# Bramcote / Stapleford

**Opun Design Review Panel  
workshop**

**11.10.16**

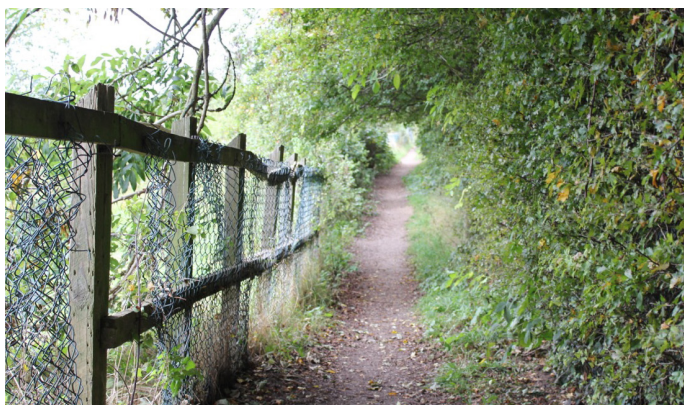
Coventry Lane (A6002) was recognised as a ready-made, integrated and connected route through the site. However, the environment of the route (high vehicle speeds combined with limited facilities for pedestrians, e.g. crossing points), will need to be addressed.

It was considered important that all of the connections, routes and access points create a legible and well-connected environment and development.

**Action:** Provision of a 'Vision' for Coventry Lane including an integrated approach (highways, landscape and urban design) addressing existing problems of connectivity, speeding and noise. Measures could include changing surface materials or re-engineering the highway which could reduce attenuation levels and provide opportunities for siting housing closer to the route. It was noted that changing the speed limit using signage would not be enough. Early dialogue on these issues with Nottinghamshire County Council Highways is encouraged.
